**Subject: Confirmation Sampling Plan for Soil, Southern RIBs Sub-Area, Henderson, Nevada**

**Response to NDEP Comments dated August 29, 2009 on the Confirmation Sampling Plan for Soil, Southern RIBs Sub-Area, Henderson, Nevada dated August 28, 2009**

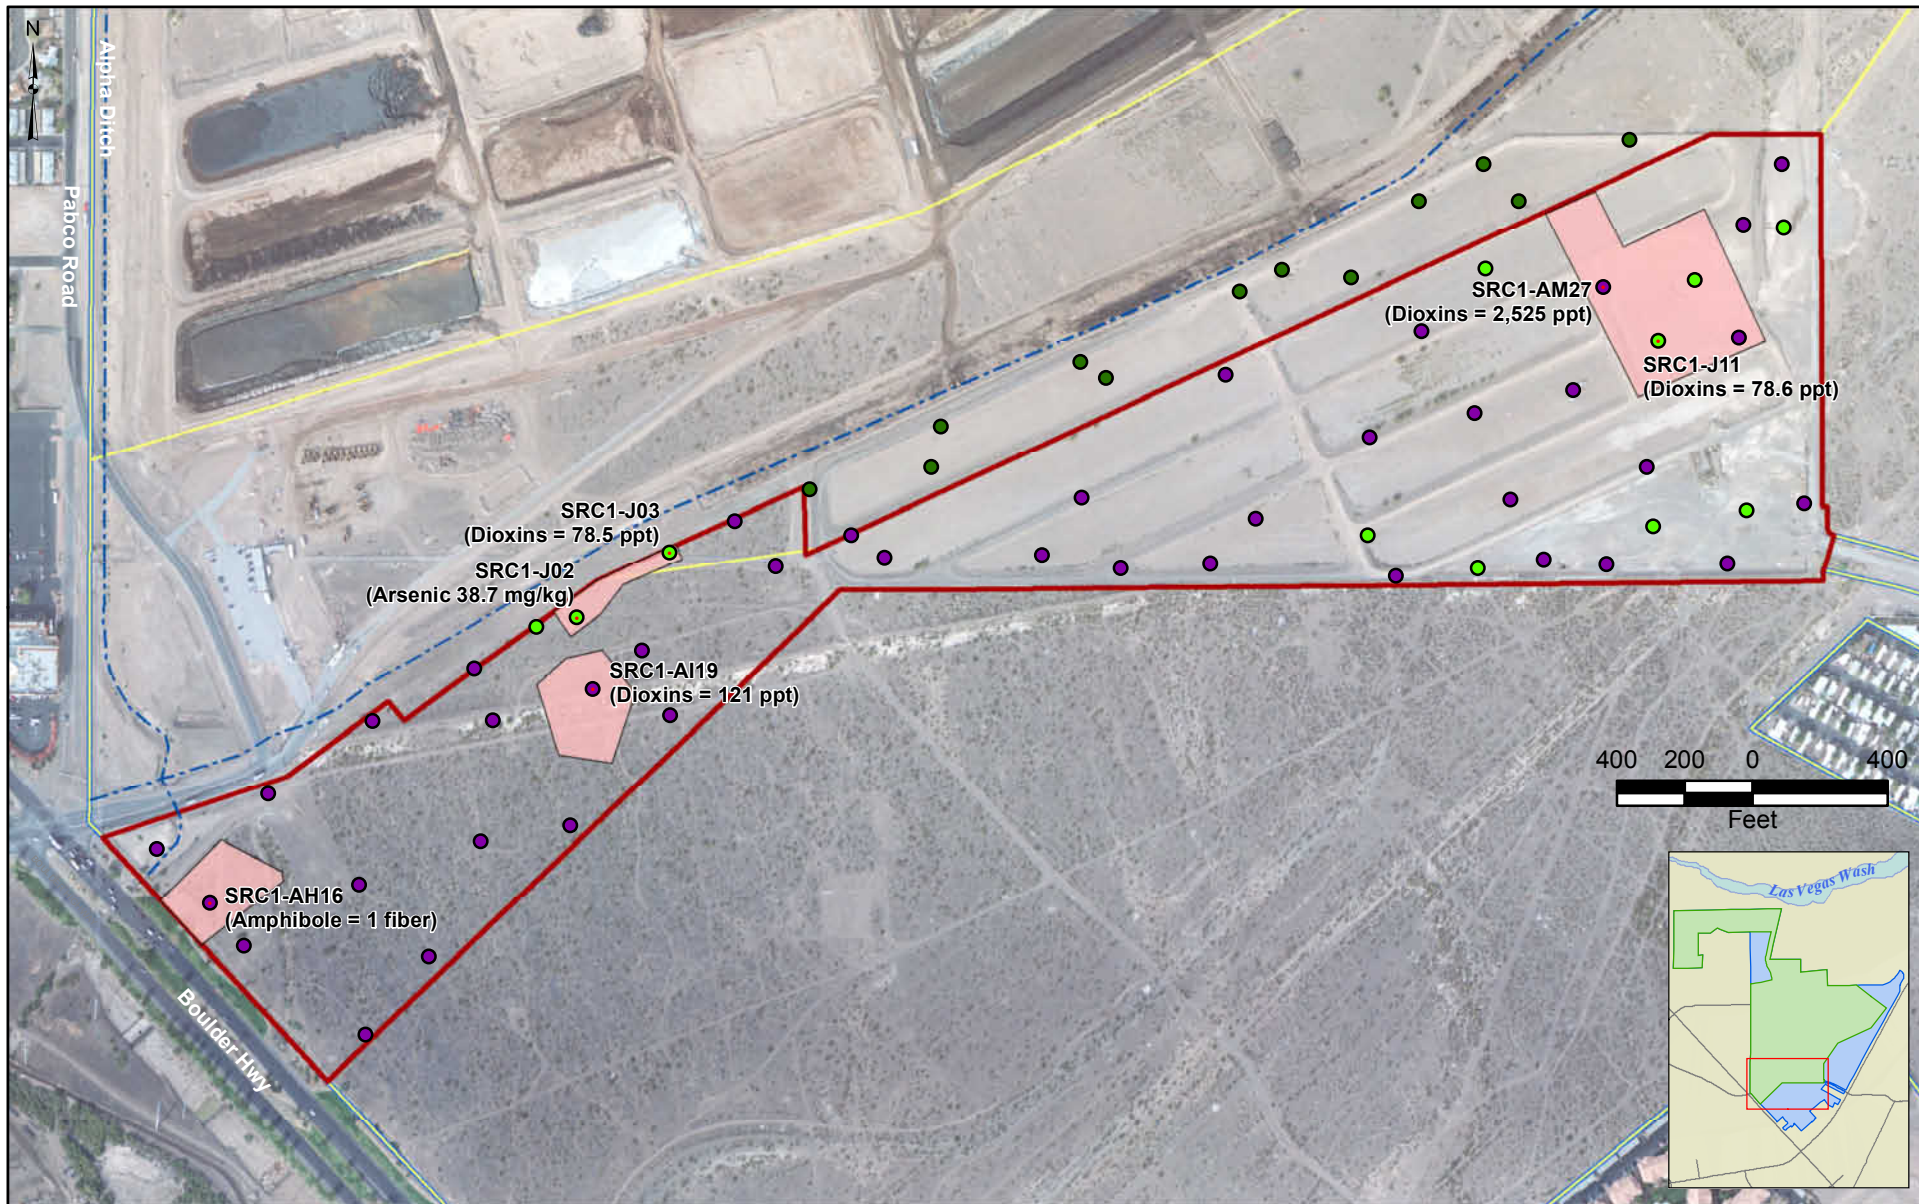
1. Figure 2, the NDEP has the following comments:
  - a. Remediation Area 1, it is requested that BRC add confirmation sampling locations to each corner of the polygon to confirm that the nature and extent of contamination has been addressed.

- b. Remediation Area 2, it is requested that BRC relocate the confirmation sampling locations to each corner of the polygon. In addition, please add a confirmation sampling point in the middle of the polygon. These changes are requested in order to confirm that the nature and extent of contamination has been addressed.

- c. Remediation Area 4, it is requested that BRC add an additional sidewall sampling location northwest of sample location SRC2-AM27C.

***Response:*** Four additional confirmation sample locations have been added to the corners of the polygon Remediation Area 1. The text, Table 1, and Figure 2 have been revised to reflect this change.

***Response:*** The confirmation sample locations have been moved to each corner of the polygon Remediation Area 2, with the addition of one corner confirmation sample location and one confirmation sample location in the middle of the polygon. The text, Table 1, and Figure 2 have been revised to reflect this change.

***Response:*** An additional sidewall confirmation sample location has been added northwest of sample location SRC2-AM27C in Remediation Area 4. The text, Table 1, and Figure 2 have been revised to reflect this change.
